Access Compliance Report Public Rights-of-Way (Curb Ramps)

Main Street: BENT_TWIG_LN Cross Street: CHIRPING_SPARROW_WAY Location: N

ADA ID: RPRK220103142615 Ramp Type: Type 1 - Perpendicular Diagonal Initial Pass/Fail: Pass Overall Compliance: No Severity Score: 6

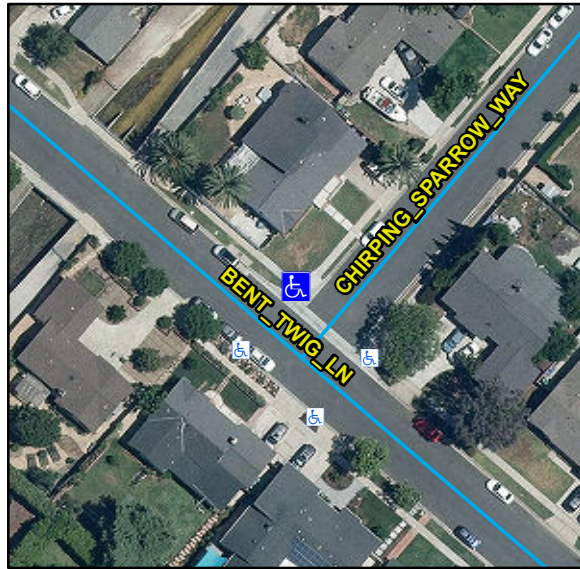
Possible Solutions:

Remove & Replace Landing.

R304.2.1, R304.2.2-Perp, R304.3.2-Para, STD 1115
